CONSTRUCTION SUMMARY

Lindsay 2017 Developments Inc. / Sugarwood

Lot/Unit: 199 Block 98 Phase/Building: 1 Model/Floor Plan: Mitchell Lake(2002)Elev B
3Bed 2.5Bath

Sketch #1

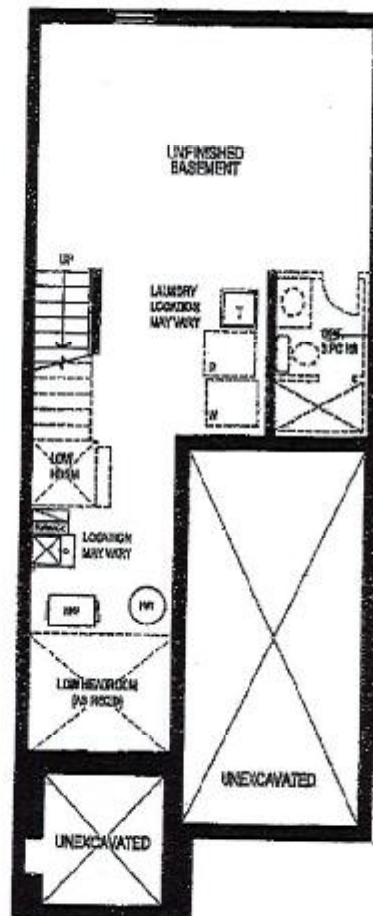
Inv.5508	1 - To supply & install the 3pc. rough in in the unfinished basement... see sketch # 1	
Line 70454	Note:	
28Mar22 / 28Mar22

- 3PC
R/E
